SUBJECT: Joan M. Durante Community Park Site Plan

SUBJECT: JOAN M. DURANTE COMMUNITY PARK: SUPPLEMENTAL STAFF
REPORT

TO: Griff Roberts, Town Manager
FROM: Daniel Gaffney, Planning, Zoning & Building Director
SUBJECT: JOAN M. DURANTE COMMUNITY PARK: APPLICATION FOR SITE
PLAN AND SPECIAL EXCEPTION APPROVAL

JOAN M. DURANTE COMMUNITY PARK
 SITE DEVELOPMENT PLANS
 SITE PLAN

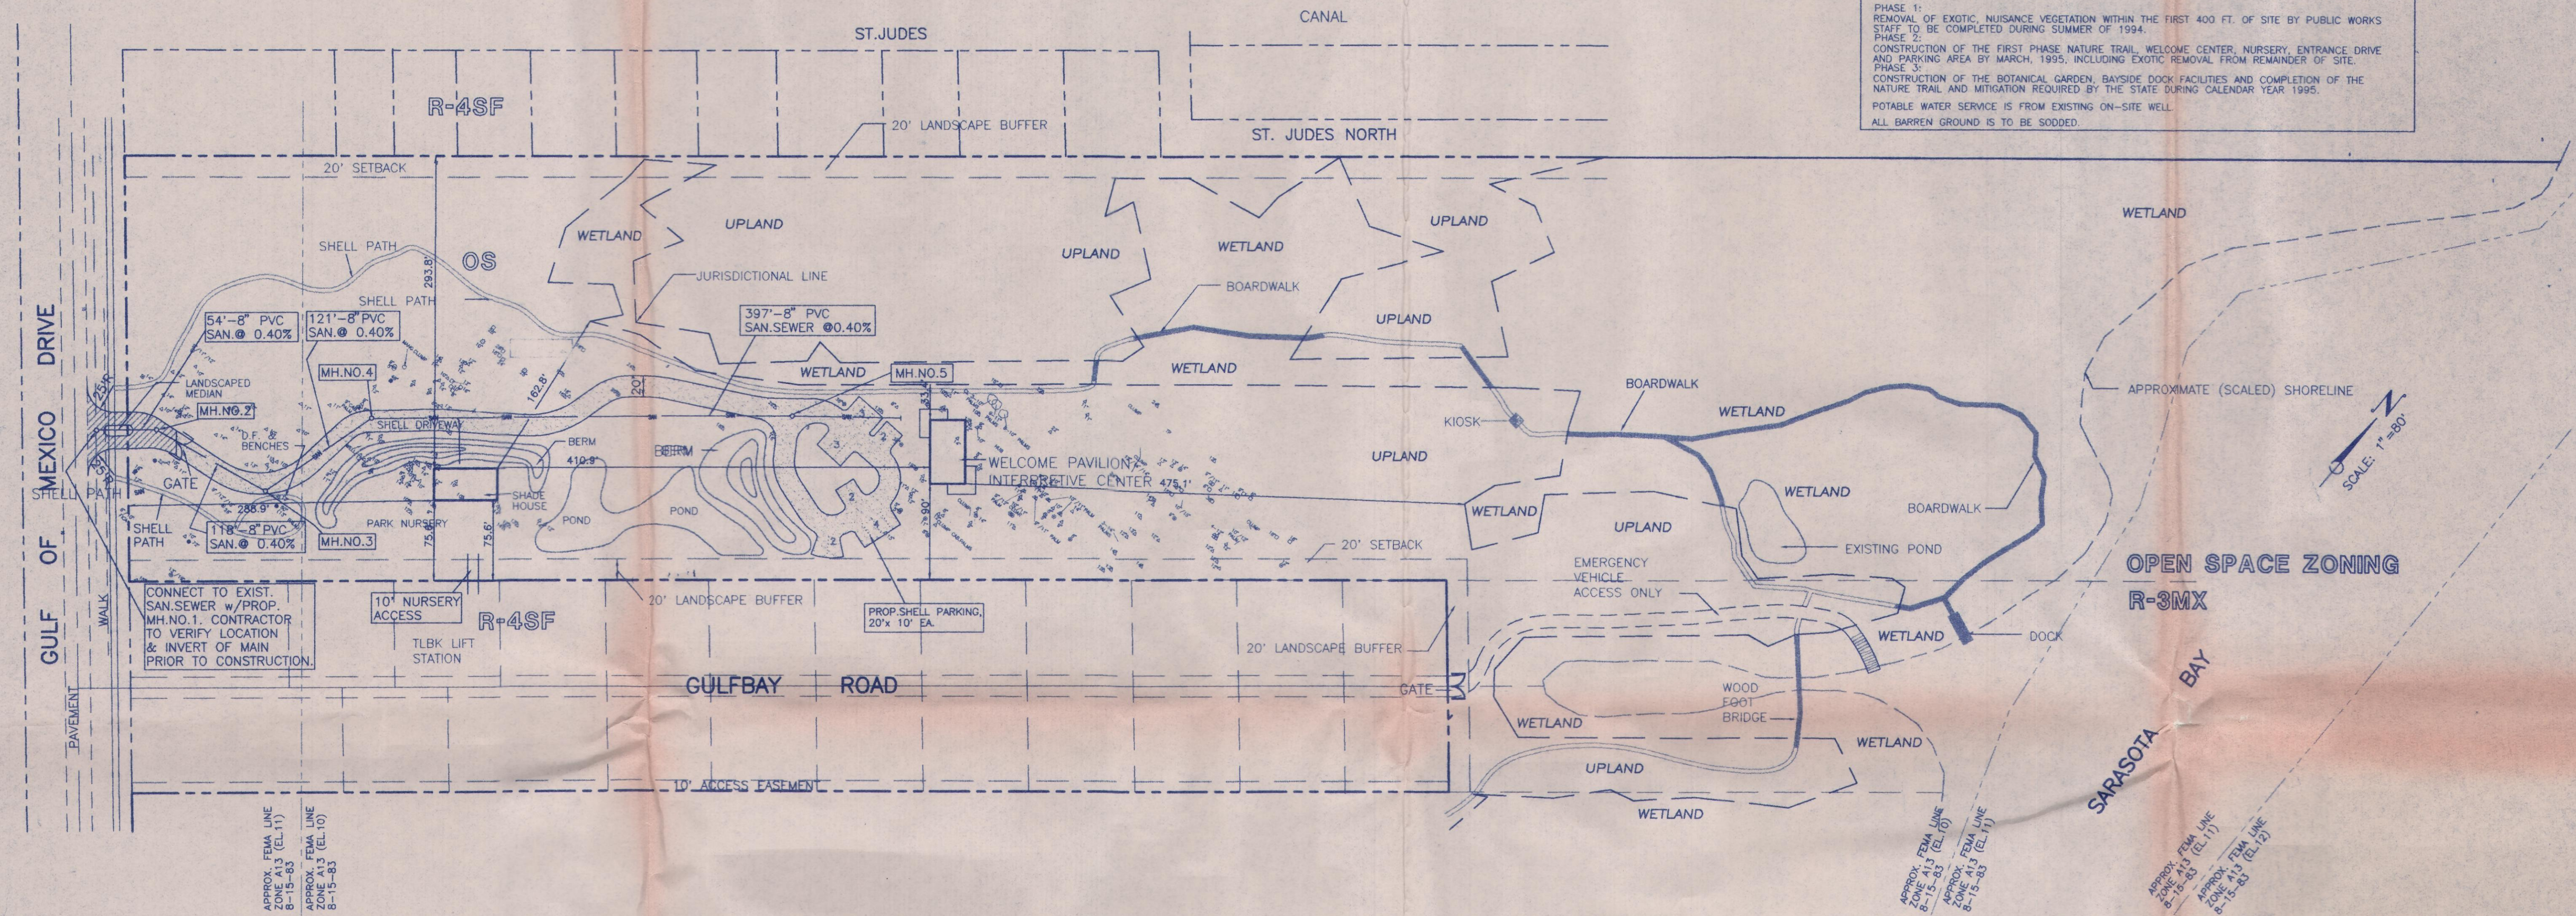
Mr. Solo questioned the width of the shell driveway for cars. Mr. Maddox replied it was 20 ft. wide. Mr. Solo asked if that was adequate for cars going both ways. Mr. Maddox stated a 20 ft. drive was considered a driveway width which was adequate. Mr. Solo asked where employees would park their vehicles. Mr. Maddox responded it was not anticipated that full-time employees would be on-site. Mr. Solo asked if there were provisions if additional parking was necessary. Mr. Maddox replied yes; it was recognized there may be times when there were more than 15 people on-site. The shell driveway, especially in the meadow part, would be constructed with stabilized shoulders that would allow people to pull off onto the edge of the drive. Mr. Solo asked if the impact from the use of the south Ansel tract had been considered. Mr. Maddox stated yes; the trails for the tennis center and the Durante Park had been coordinated so they would join together.

Mr. Monroe asked Mr. Maddox to explain the details of the pavilion. Mr. Maddox responded that with the Americans With Disabilities Act, the Town was required by Code to provide facilities for the handicapped, and from a health and safety point, restrooms would be required by Code for visitors. He said if restrooms were included, they would consist of a single toilet facility for the convenience of those visiting the site. Mr. Gaffney commented that the Town Attorney would be verifying what the code requirements were; he would be reviewing, in particular, the state health code and state plumbing code. He said at this time it appeared that restrooms would be required. Mr. Monroe asked if restrooms would be required if there were no buildings. Mr. Gaffney responded that was an issue that was brought to staff's attention by both Manatee and Sarasota County's health departments; the restrooms may be required with or without a building based on state code requirements. He pointed out that if the restrooms were required and included, they would be designed in accordance with the Florida House Program, where they would use cisterns to flush the toilets. He said all the rain water would be collected in the cisterns and would negate the need for any stormwater management program or potable water supplies to the building.
